SUBJECT: Council Request CR 17-198: PUD Rezoning for 1327 W. Tufts Ave.

Attached please find all of the items submitted to the Development Review Team (DRT) and the associated plan review comments from City staff for the proposed PUD rezoning at 1327 W. Tufts Ave. The proposed conceptual plans have evolved since last April with the applicant making plan revisions to respond to technical comments. Three different DRT case numbers were assigned as the project evolved, they are described briefly below.

Project Number	DRT2017-019	Applied	4/18/2017	JKL
Project Name	Potential PUD for townhomes	Approved		
Type	DRT	Closed		
Subtype	SITE DEVELOPMENT	Expired		
Status	STAFF REVIEW	Status		
Owner	1327 WEST TUFTS AVENUE LLC	Applicant		
Site Address		City		
1327 W TUFTS AVE		ENGLEWOOD	State	Zip
			CO	80110-5524
Subdivision		Tract	Block	Lot No
				Parcel No
				2077-09-1-00-020
Zoning		General Plan

Project Number	DRT2017-036	Applied	7/24/2017	NGF
Project Name	Site Development Possible PUD	Approved		
Type	DRT	Closed		
Subtype	SITE DEVELOPMENT	Expired		
Status	STAFF REVIEW	Status		
Owner	West Tufts LLL	Applicant	West Tufts LLL	
Site Address		City	State	Zip
1327 W TUFTS AVE		ENGLEWOOD	CO	80110-55

SITE PLAN OPTION

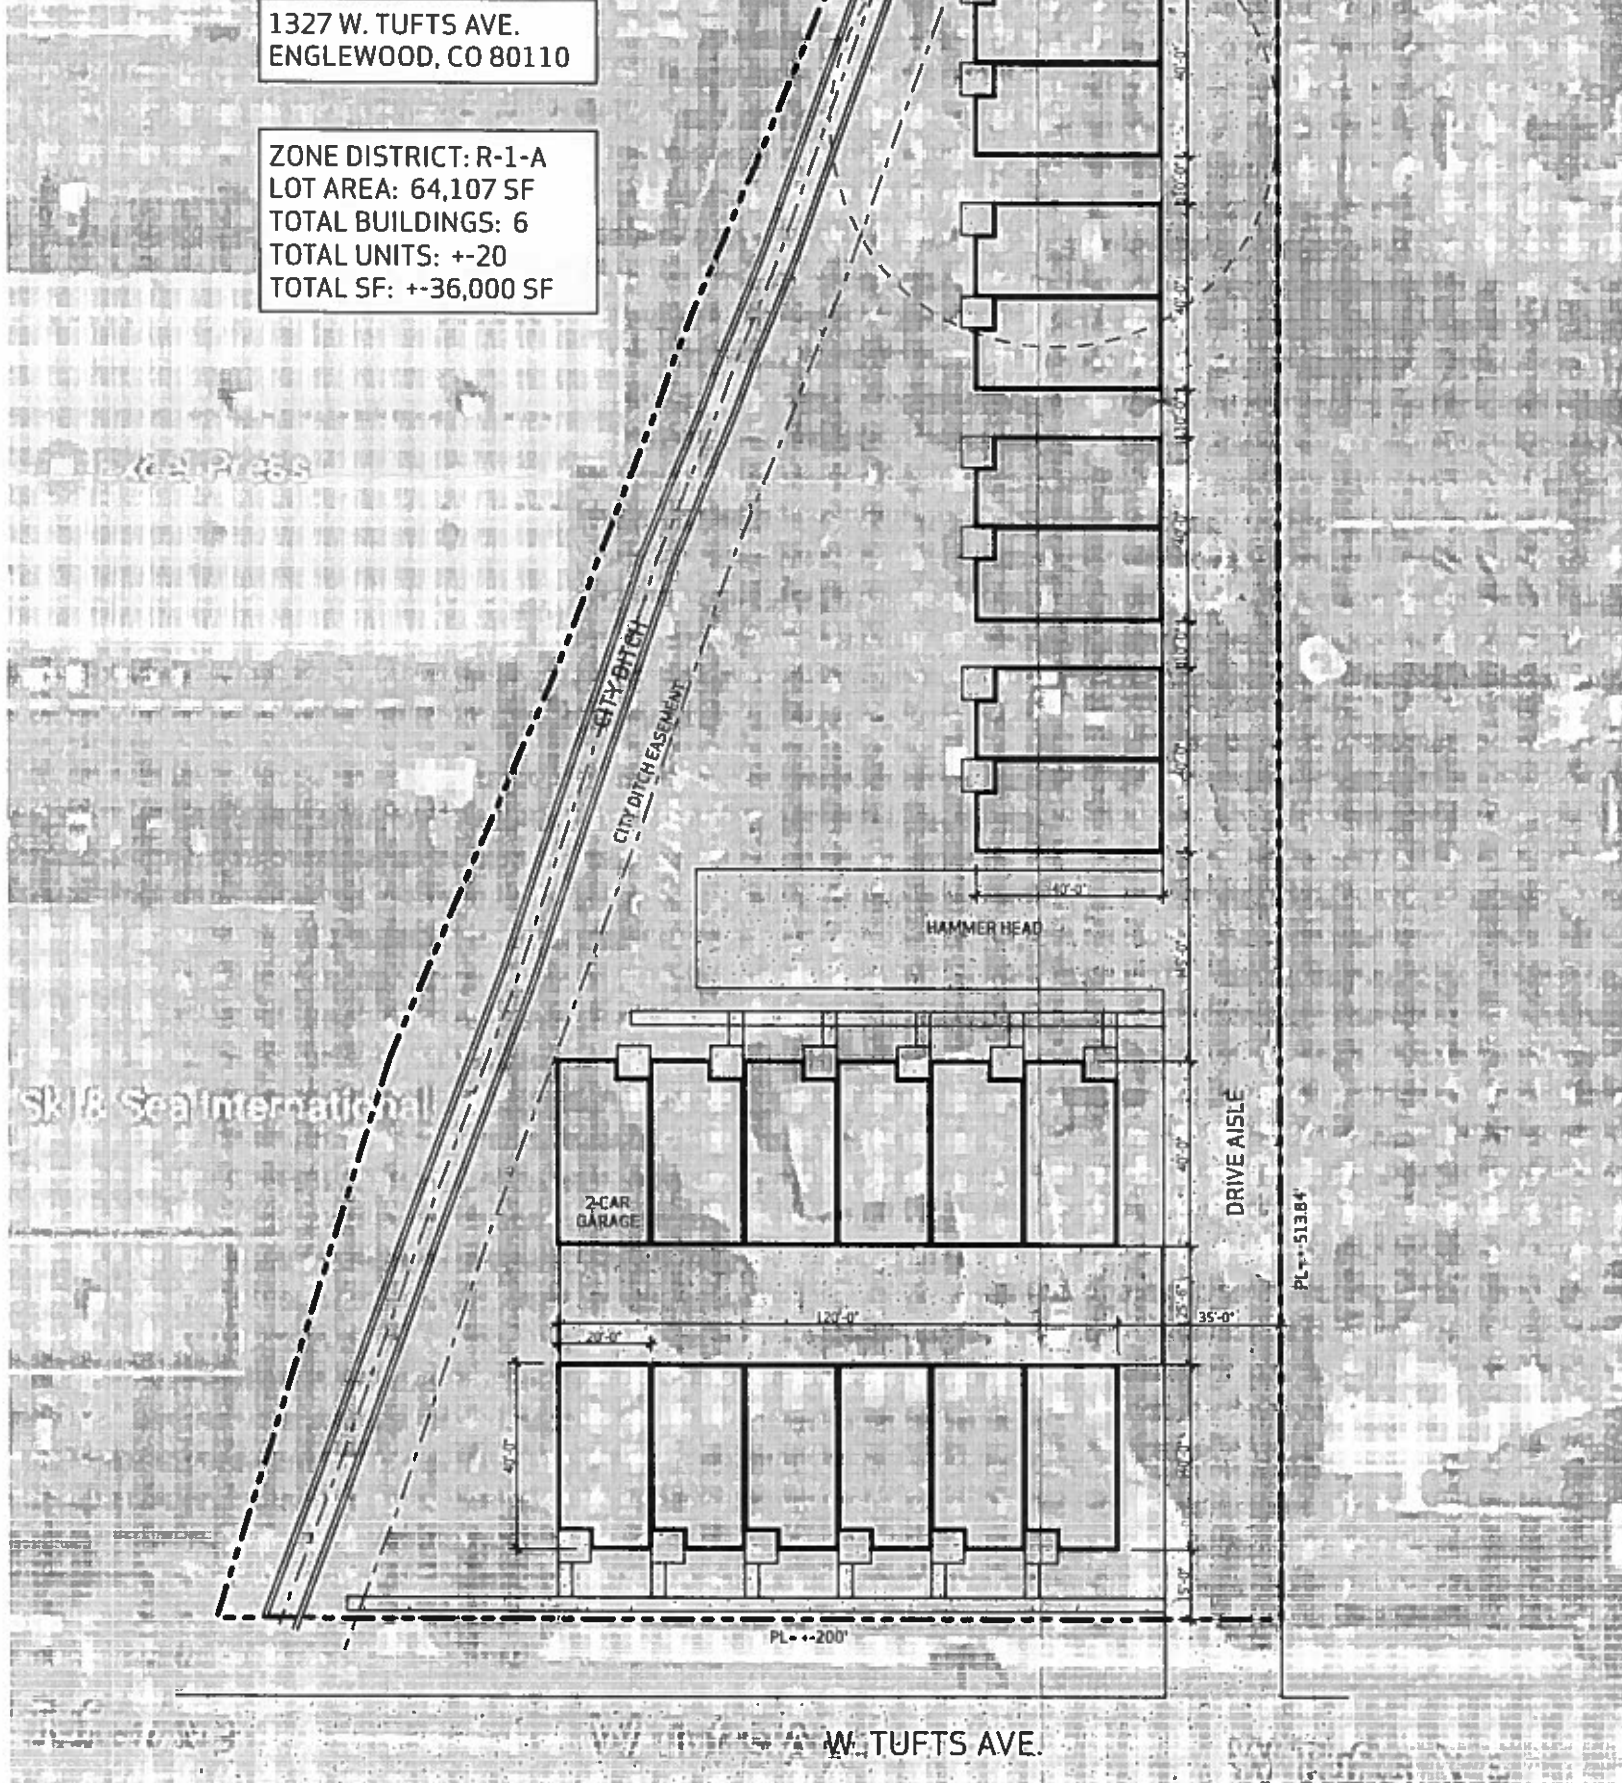
Type / Status / Contact / Notes	Dates				Remarks
	Sent	Due	Received	Elapsed	
Building (303)762-2355 APPROVED KERRY BABIN <i>kbabin@englewoodgov.org</i> (4/25/2017 3:08 PM KMB) No floor plan was provided. Further guidance can be given once that is obtained. Current minimal Englewood code cycles must be met. Be mindful of propert setback and fire ratings. (5/4/2017 12:30 PM KMB) Good afternoon. Please see below in regards to the adoption of the 2015 building codes in Englewood, CO. “Earlier this year, you attended a Development Review Team meeting and presented your project. As you know, the City has been going through the process of adopting the 2015 International Code Cycle. We are hoping to have the codes adopted in the next few months but do not have a set date for adoption. We will be unable to approve plans designed under the 2015 code cycle until such time that the City formally adopts the code. Please check our website or contact us periodically for updates on the code adoption process. We will continue to review and approve plans under the 2012 code cycle. Regards, Karen Montanez Chief Building Official City of Englewood”	4/18/2017	4/25/2017	4/25/2017	7

Comm Dev (303)762-2352 NOT APPROVED JEREMY LOTT <i>jlott@englewoodgov.org</i> (5/10/2017 9:52 AM JKL) PUD process would have to be complete prior to development	4/18/2017	4/25/2017	5/11/2017	23	
ENGINEERING (303)762-2505 APPROVED W/COND PAUL WELLER <i>pweller@englewoodgov.org</i> (4/25/2017 4:40 PM EML) All work shall be completed in conformance with Englewood Storm Drainage Criteria Manual and Construction Standards and	4/18/2017	4/25/2017	4/25/2017	7	See Notes

This project would be reviewed under the 2012 International Fire Code (IFC) with amendments.					
Access not compliant: Per 2012 IFC, (See Appendix D) with amendments the width of access roads must be a minimum of 26 feet					
Hammerhead not compliant: Per 2012 IFC, with amendments when a dead-end fire apparatus access road exceeds 150 feet (151-500) a minimum 26' wide, 120-foot hammerhead is required.					
The drive aisle is approximately 380', with the northern aisle exceeding 200'. A turn-around shall be installed to eliminate the 200'+ dead-end

Type / Status / Contact / Notes	Dates			Elapsed	Remarks
	Sent	Due	Received		
Hydrant locations need identified					
Per the amended 2012 IFC, the minimum turning radius shall be 55'.					
Your specific code analysis will determine the applicable code requirements that will be specific to your project at the time of submittal. A Code Analysis shall be provided and include the following: -Use and Occupancy Classification -Occupant Load -Construction Type -Allowable Area Calculations including code provisions used to obtain increases -Actual floor area of the building -Number of stories and height of building -Identify new and existing fire sprinkler systems -Applicable codes, amendments or approved requests for modifications -A Knox box would be required. A master key(s) shall be provided to the Fire Marshal's Office at final inspection to be placed in this secured key box. Visit WWW.KNOXBOX.COM to order the Knox Box. The Knox Box shall be keyed to the Englewood Fire Department. *The Denver Fire Department will be emergency response agency to this location. **This list is NOT ALL-INCLUSIVE and is to be utilized as guidance ONLY for a consideration during plan submittal. Plan reviews are based on the information presented to the City of Englewood at the time of plan submittal. Any changes made prior to the plan review being submitted shall be subject to approval, which may result in additional or different compliance requirements.

SITE PLAN OPTION

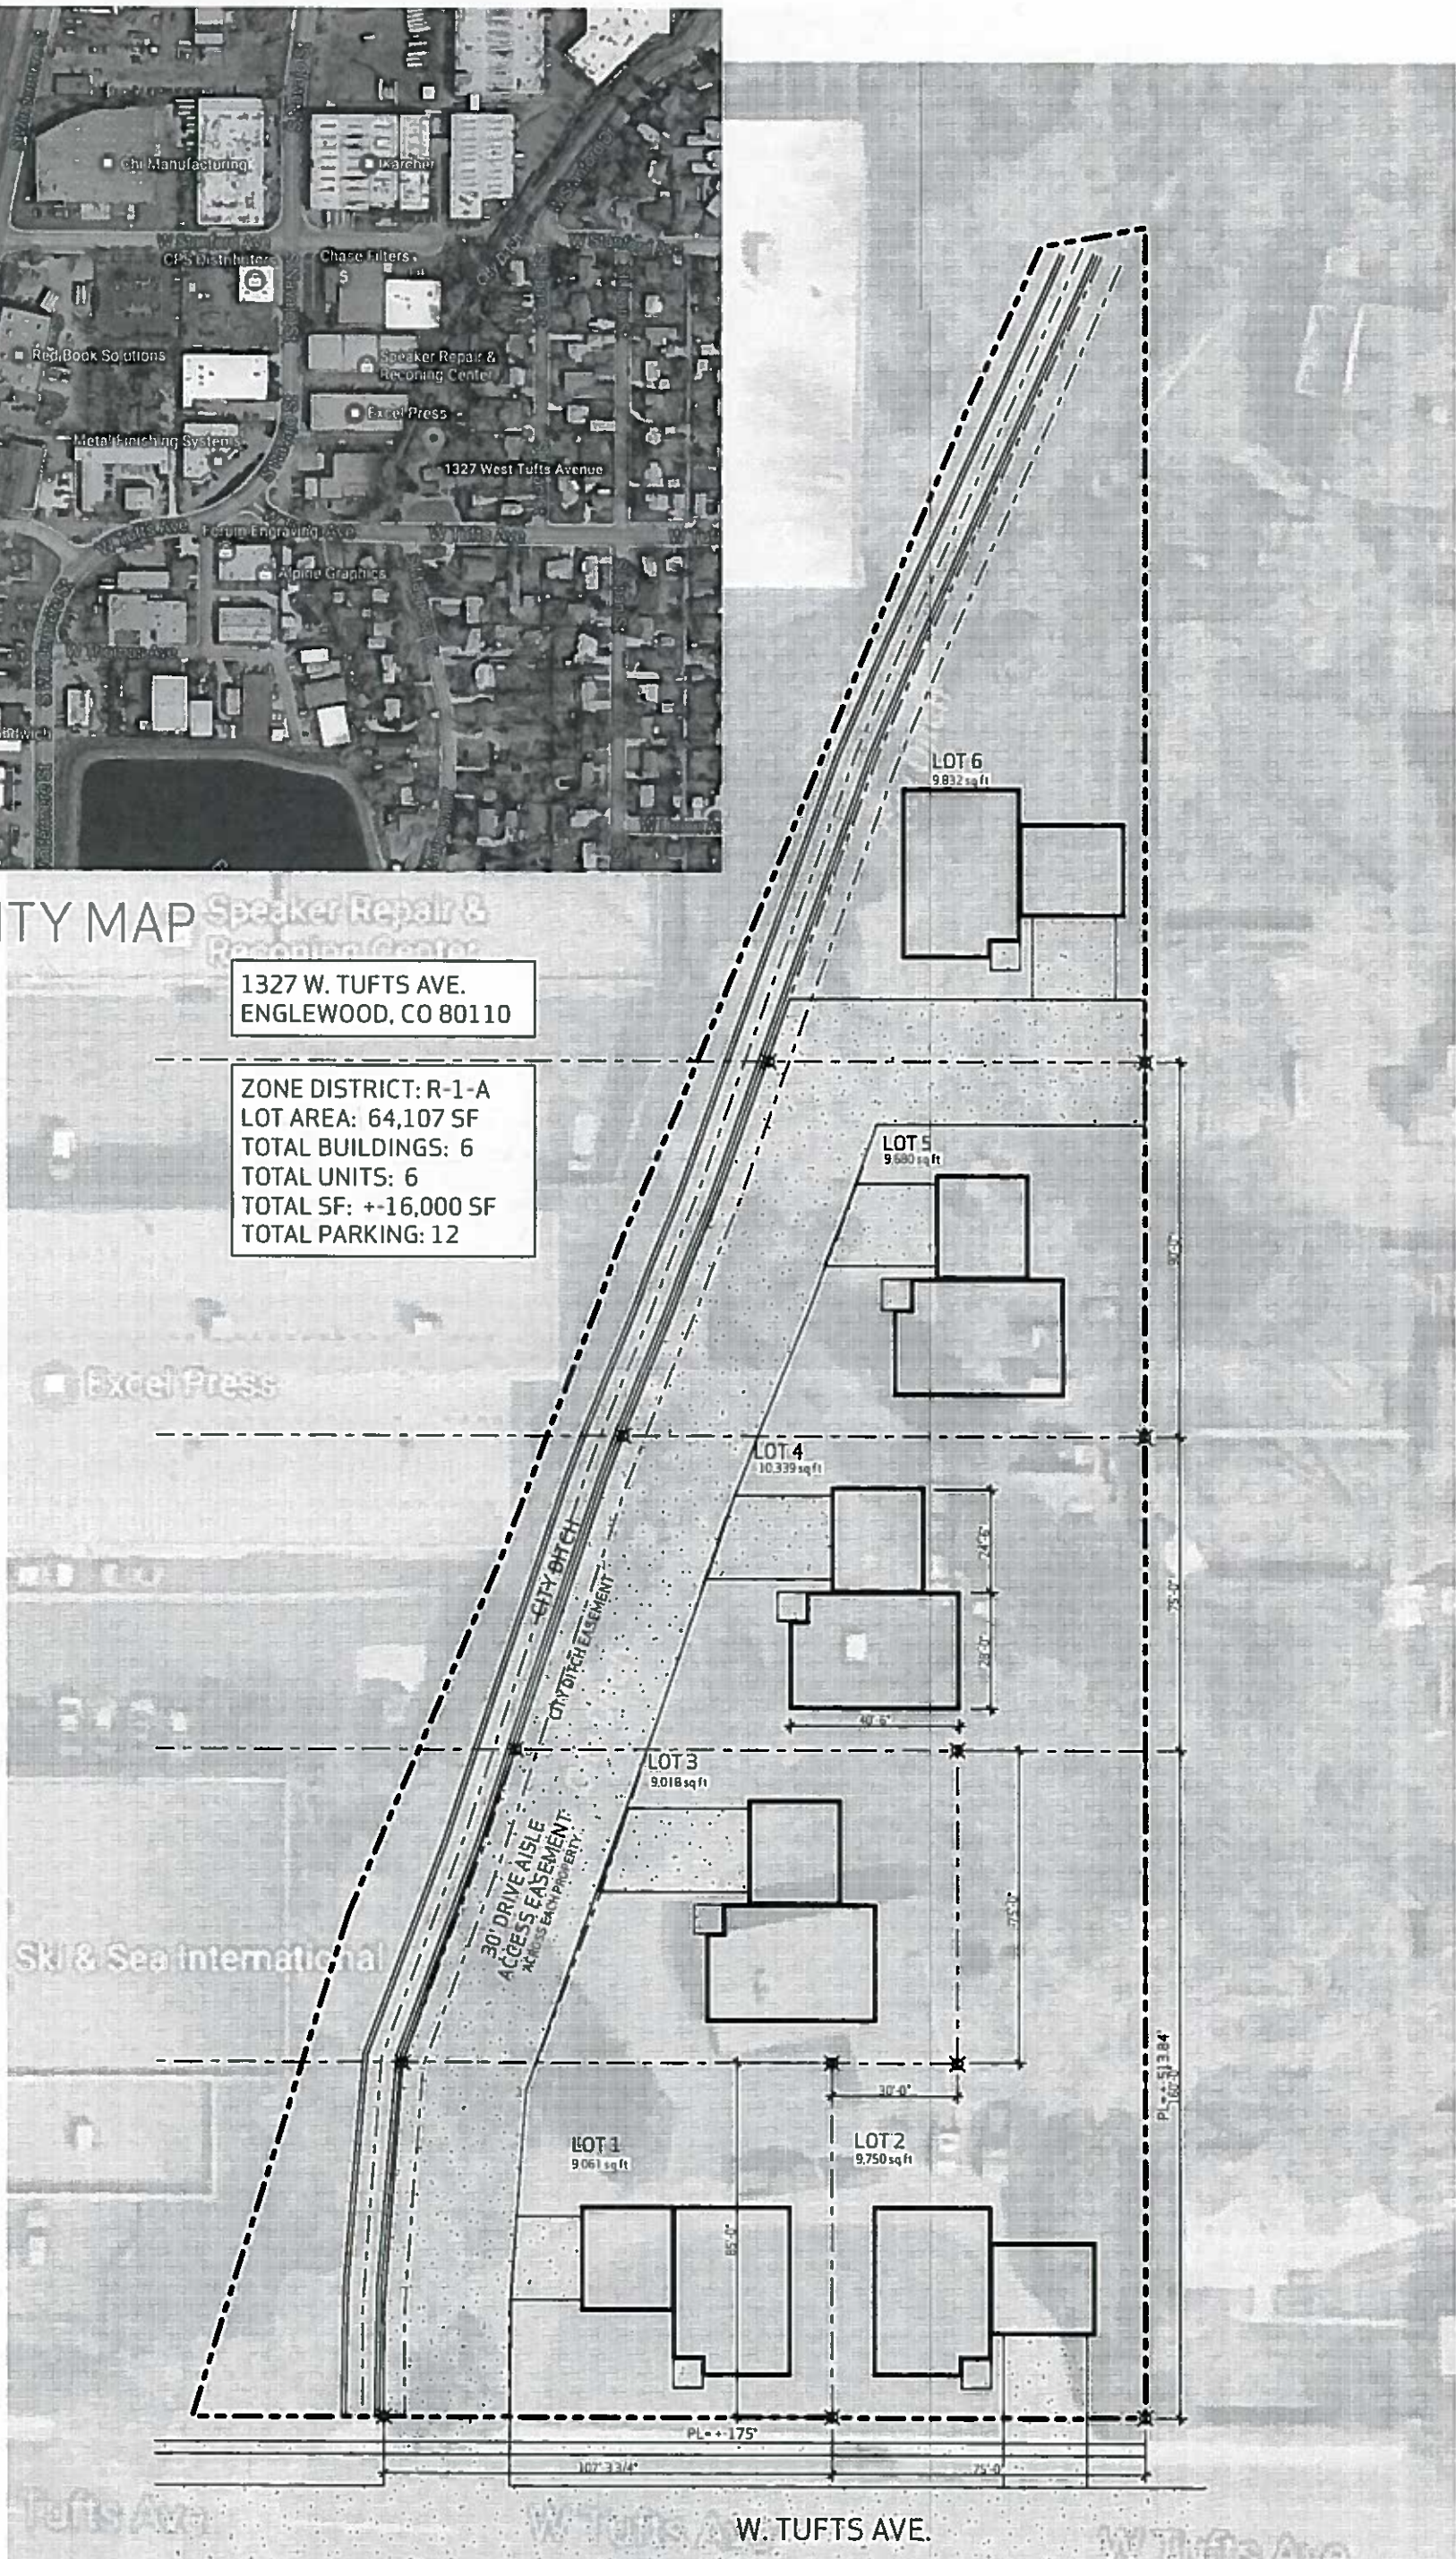
Type / Status / Contact / Notes	Dates				Remarks
	Sent	Due	Received	Elapsed	
Comm Dev (303)762-2352 NOT APPROVED JEREMY LOTT <i>jlott@englewoodgov.org</i> (5/24/2017 8:09 AM JKL) Park fee in lieu for each unit would be \$460. Credit for 1 unit from existing house. Lot coverage maximum is 35%. There are different exemptions for various items. Setbacks - Front 25 feet, sides 7 feet, rear 20 feet. Max height 32 feet. Bulk plane would apply.	5/19/2017	5/23/2017	5/31/2017	12	
ENGINEERING (303)762-2505 APPROVED W/COND ELYSA LOEWEN <i>eloewen@englewoodco.gov</i> (5/23/2017 11:07 AM EML) Per City of Englewood Storm Drainage Criteria Manual section 2.0 for a site greater than 1.0 acre (approx 1.5) a letter report and final drainage report, and a stormwater management plan (SWMP). Permanent water quality facilities and storm water detention are required construction per City of Englewood Storm Drainage Criteria Manual section 2.0 Submit Stormwater Management Plan to identify all erosion, sediment and water pollution controls that will be installed and maintained throughout construction per City of Englewood Storm Drainage Criteria Manual section 2. All work shall be completed in conformance with Englewood Storm Drainage Criteria Manual and Construction Standards and Concrete Specifications for the City of Englewood, Colorado. Current Public Works Standards can be found on the City of Englewood Website >> Inside City Hall >> Download Documents >> City Departments >> Public Works. Documents include the Construction Standards and Concrete Specifications, Storm Drainage Criteria Manual and the Drainage Study for the 100 year storm that identifies local areas that may be affected by stormwater runoff from a 100 year storm. All curb ramps shall meet current ADA standards. Detectable warning panels shall be "CASTinTACT" or approved alternate. A separate Grading, Erosion and Sediment Control permit will be issued for this project for the installation of construction BMP's,	5/19/2017	5/23/2017	5/24/2017	5	See Notes

in note 2, disregard note about detention, it is not required for this size lot, permanent water quality facilities only**

- 1. The 30' drive aisle indicates that it is to be an access easement "across each property".
 - a. What would this road surface consist of?

- b. Who would maintain this?

- c. Who would own this?

- 2. The drive aisle/access easement is over 150' and would require an approved turnaround for fire apparatus per the 2012 IFC. The drawing indicates it dead-ends between Lot 5 and 6.

- 3. What are the proposed hydrant locations planned? Existing?

A: Asphalt or concrete

A: Home owner association

A. each of the owners would own the portion that their property fronted on and an easement would be granted the balance of the owners

A. We will but a firetruck template onto the site plan but we anticipated that this would allow enough room for the 2012 IFC.

A. what does code require as it relates to hydrants?
